Advanced LIGO PSL

presentation of the PSL team at the
preliminary design review

LIGO-G080539-00-Z

HPL – more likely failures

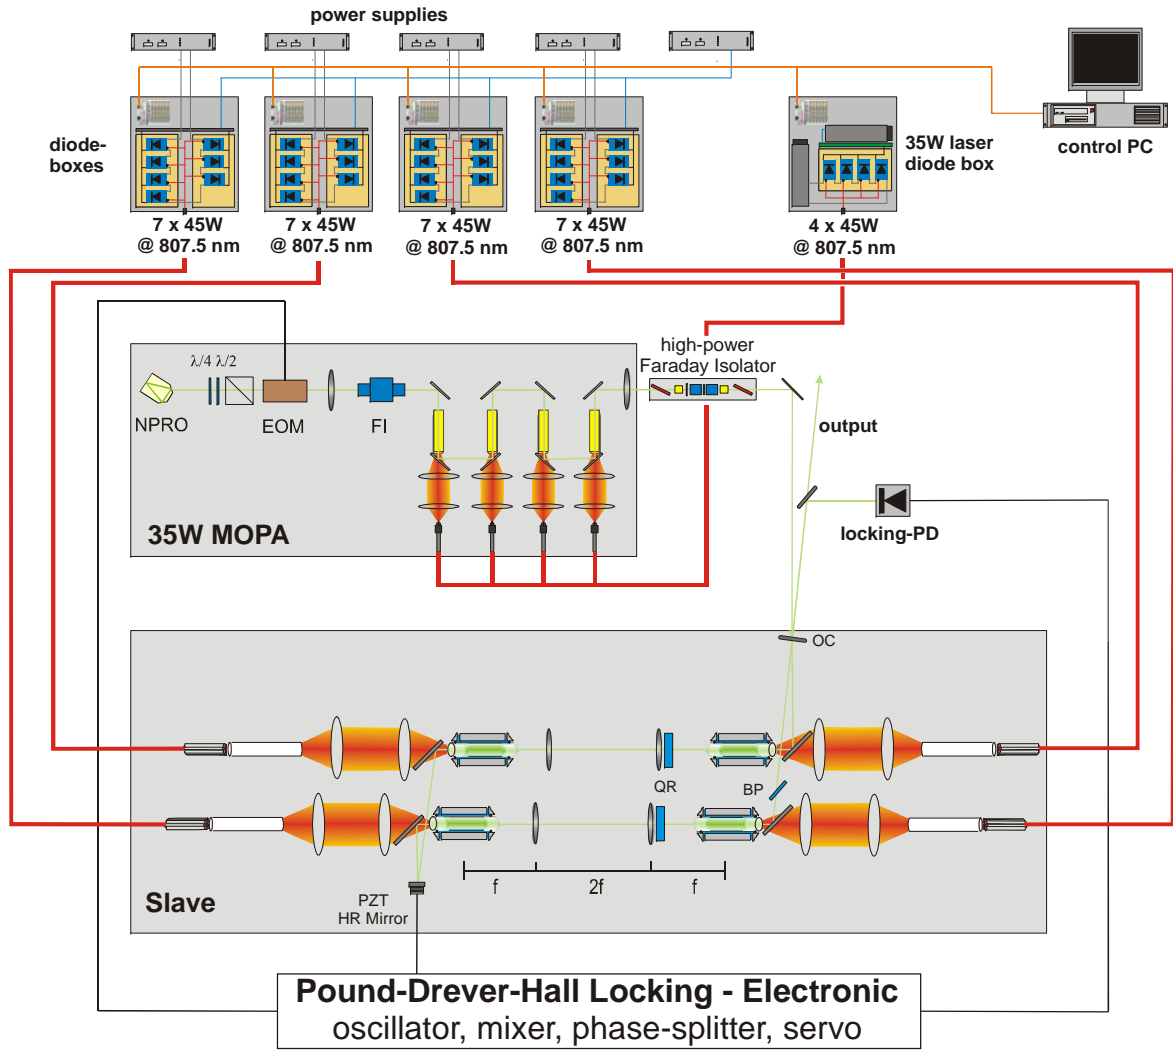
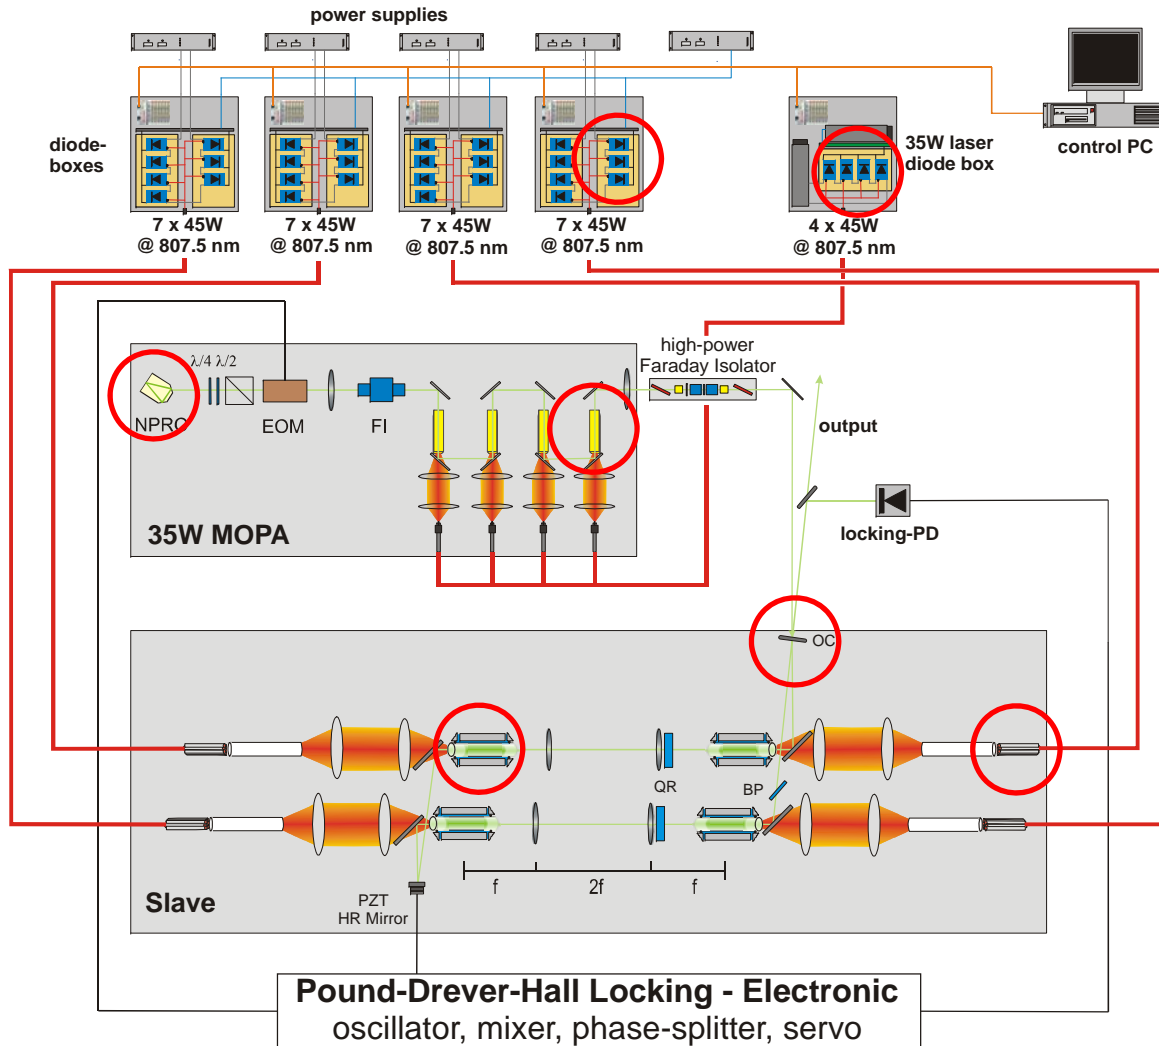
D: Repair. What are the more likely failure modes for the PSL, and the estimated time to repair for those modes?

- PMC transmission degrades
 - mitigation
 - replace PMC
 - degradation should appear slowly -> replacement can be done in scheduled maintenance time
- PSL electronics fails
 - mitigation
 - replace with spare
 - replacement and tuning should be possible within 1 day

- NPRO
- Pump diodes
- 35W MOPA:
 - Laser crystal
- High power slave:
 - Output coupler
 - Laser crystal
 - Fiber bundle
- Water leakage

Cause:	?
Action:	<ul style="list-style-type: none">• Replace 35W MOPA with spare• Realign spare 35W MOPA• Verify 35W MOPA beam parameters• Check mode-matching to slave laser
Duration:	~ 2 days

Cause:	Natural degradation of emitter material / electrical or optical failure
Action:	<ul style="list-style-type: none">• Depending on age of pump diodes:<ul style="list-style-type: none">• „Young“ diodes: replace single diode• „Old“ diodes: replace complete diode box with spare• Verify output power and spectrum parameters
Duration:	~ 1 day

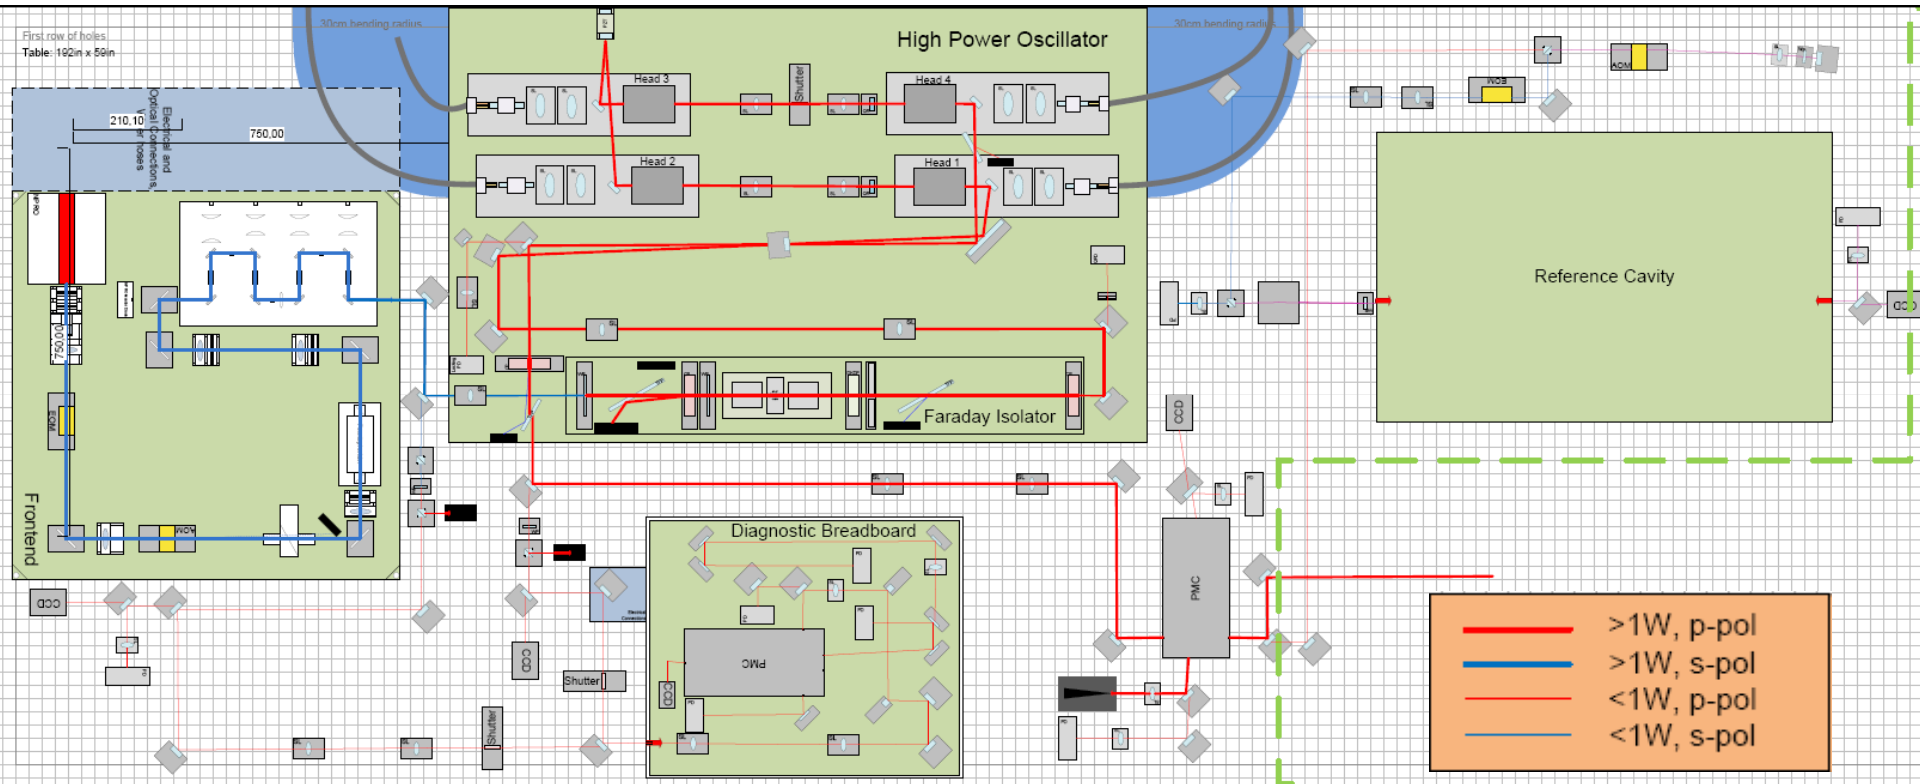
H: Loop gain monitors. We find we need to adjust the gain of the FSS every few months or so to maintain the desired ugf for this loop....Similarly, loop gain monitors for the ISS and PMC servos should also be implemented. We can discuss more what we have in mind at the review.

- we will provide three function generators (with option to lock to master clock) for calibration lines to be injected into FSS, ISS, and PMC servo
 - frequencies within loop bandwidth, TBD
 - amplitude TBD
 - additional AWG lines can be used during maintenance intervals during automatic “health-monitoring runs”

PSI layout

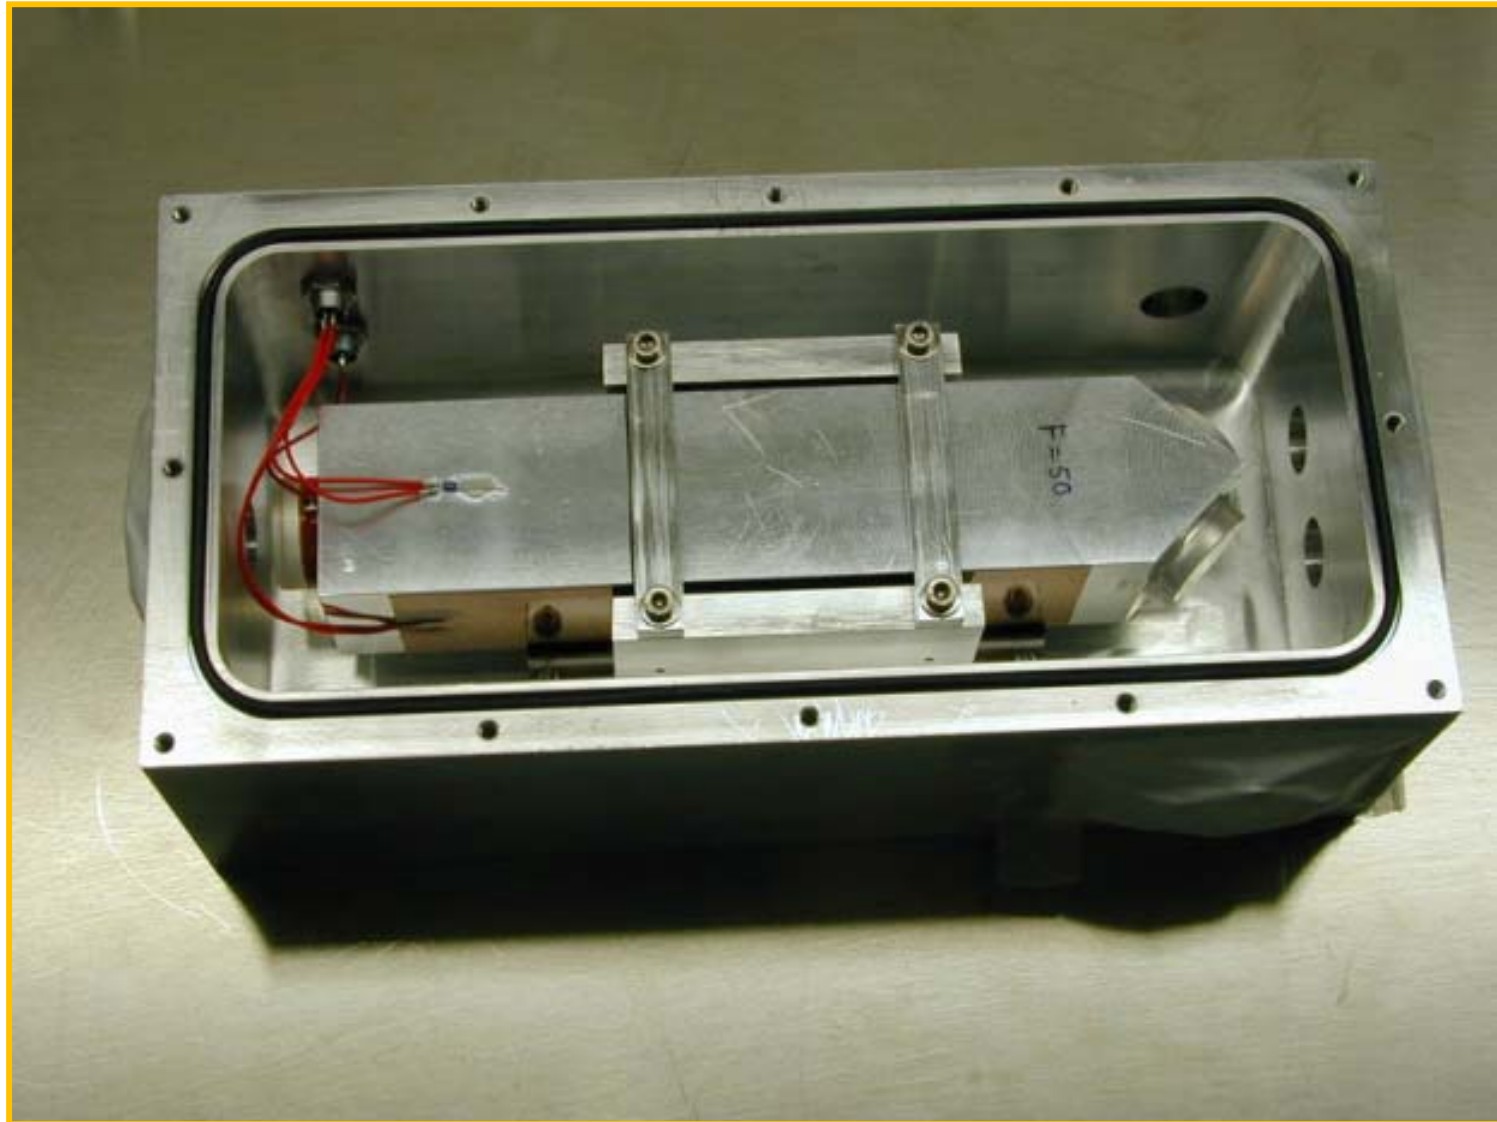
I: List all the locations where PSL beam power is monitored (include this in the PDD too).

- NPRO power
 - right before injection into 35W amplifier (relaxation oscillation monitor diode)
- 35W laser
 - continuously in DBB path
 - optional with DBB
- 200W laser:
 - injection locking diode (in laser box)
 - optional with DBB
 - PMC transmission (RPN diode)
 - PMC locking

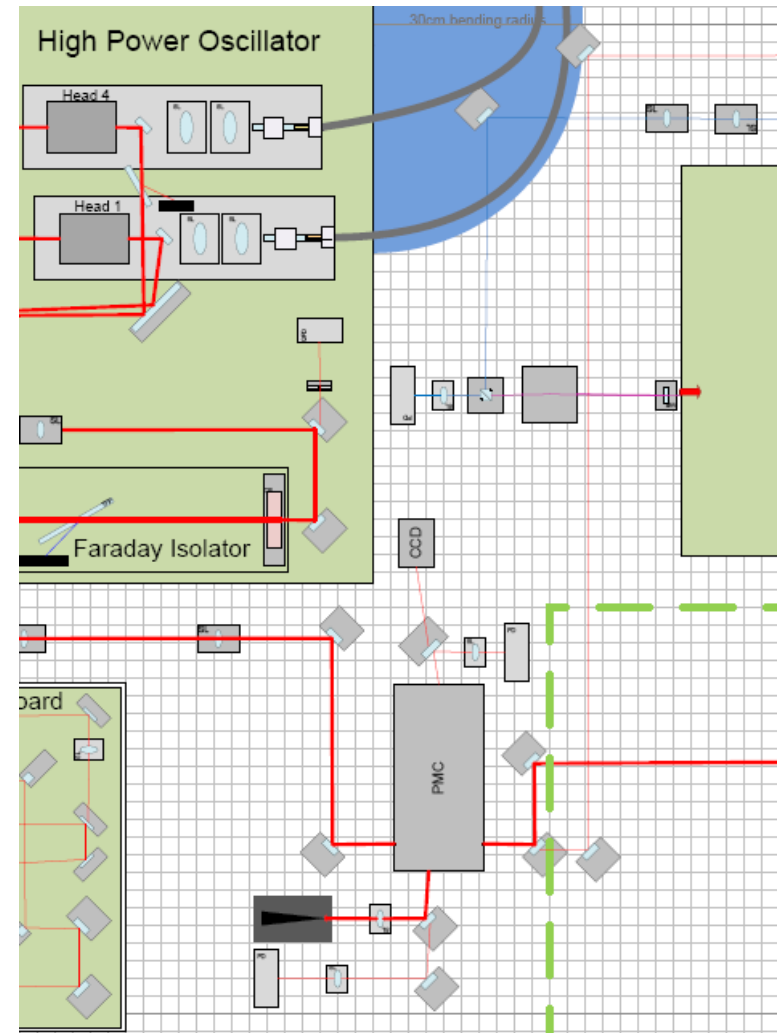
J: The ISC design is now working with 100 ma of detected power on some of their photodetectors, and at the level the RF noise looks a little marginal. Could the PMC be designed to give another factor of 2-3 filtering at 9 MHz? : How about using a 4-mirror bowtie design, where the optical path can be essentially doubled in the same physical space?

- constraints on length with current table layout, if we want to allow for IO beam measurements with DBB
- 4 mirror bowtie might be possible
 - astigmatism higher
 - additional and test effort
- could try to increase Finesse by factor 2
 - thermal loading experiments with 180 FPT and DBB

35 W laser behind F=380 PMC

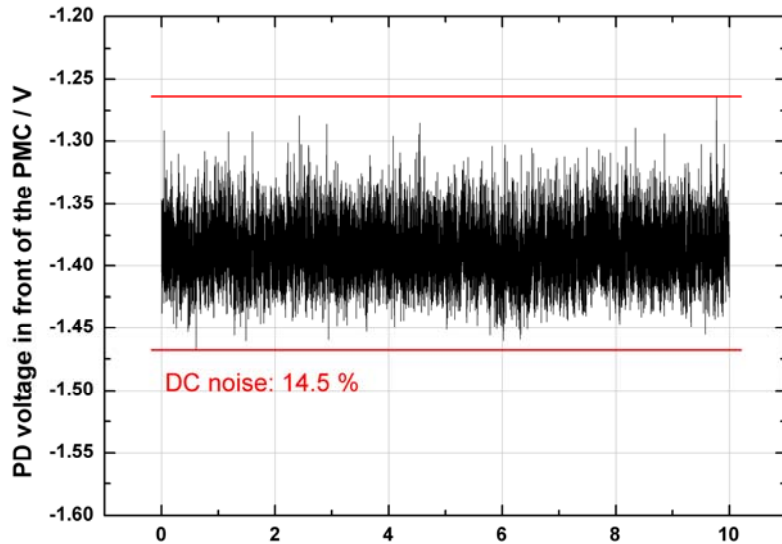
J: Will the PMC output beam parameters change much in going from low to high power modes?

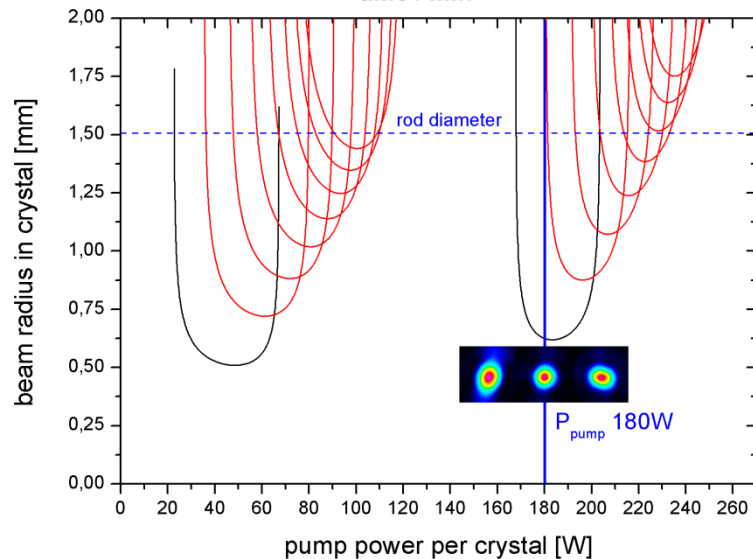
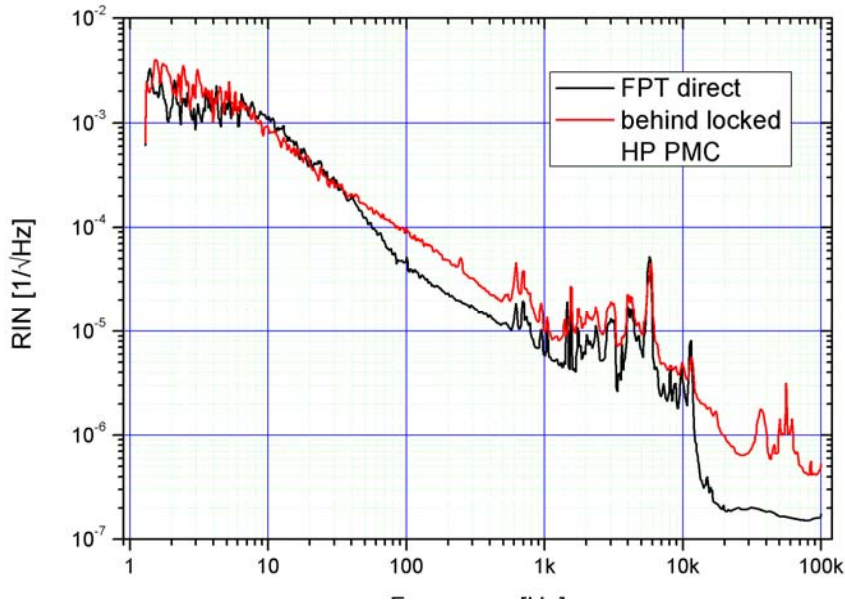
K: Power fluctuations. Fig. 18 shows 15% pk-pk variations compared with the target of $1e-4$; how do you get from here to there?

- reduce the free running noise
 - improved diagnostics to find main noise source
 - choose more stable operation point
- use feedback control
 - actuator with large enough range
 - 180W pump source
 - PMC
 - AOM
 - evanescent field prism

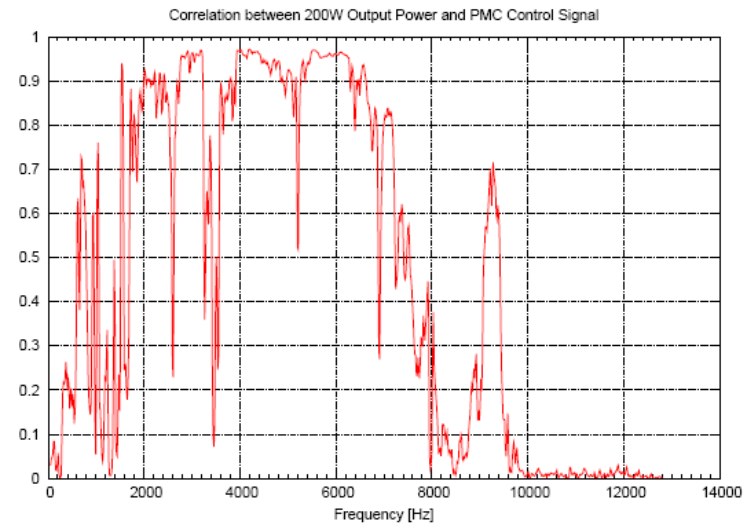
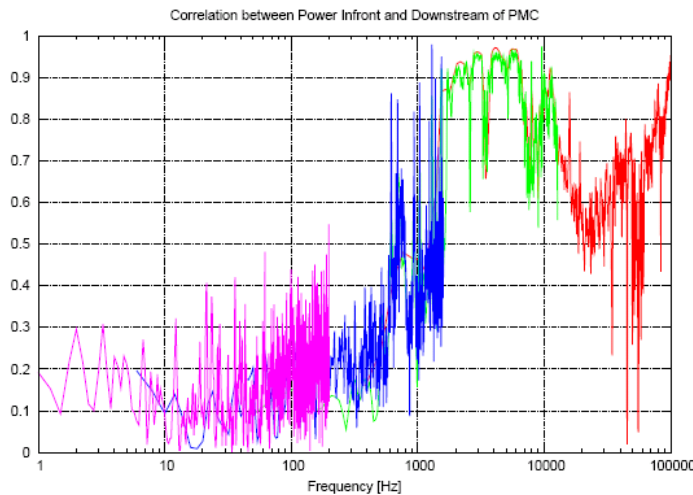
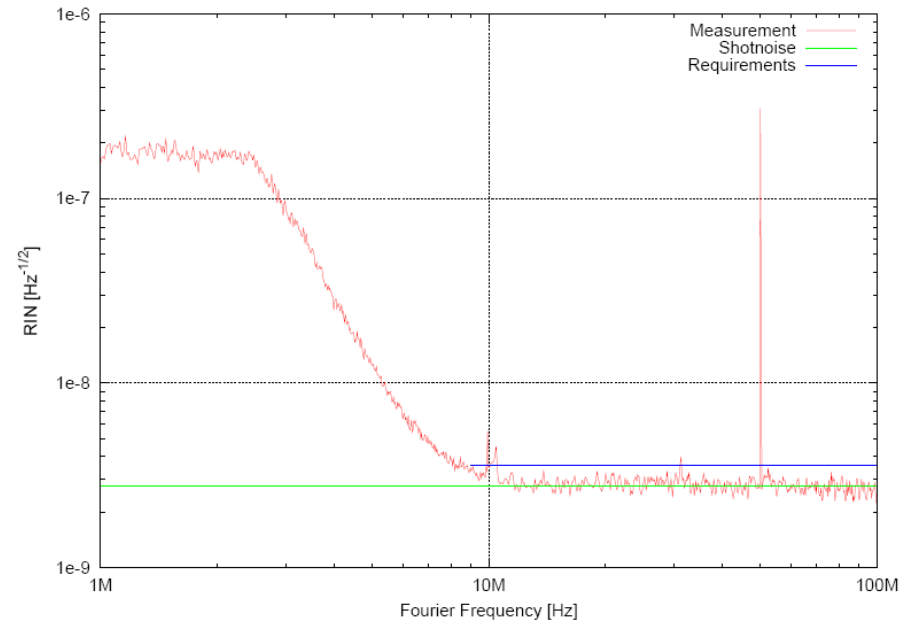
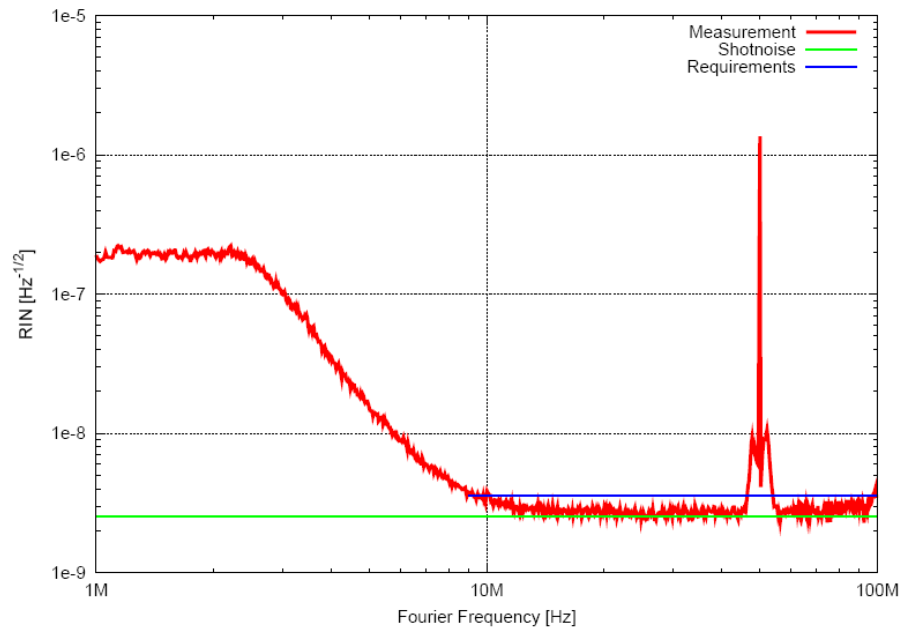
K: Fig. 17 seems to show higher noise after the PMC than before; what is going on here? Fig. 37 has a spectral peak with some wide shoulders at 50 MHz; what are these due to and will they be eliminated?
 Also longer term: did you look at effects of environment temperature and humidity?

- higher RPN after PMC due to cross coupling
- strong coupling between 180W RPN and PMC error signal
- strong coupling between RPN and IJL error signal
- needs further investigations
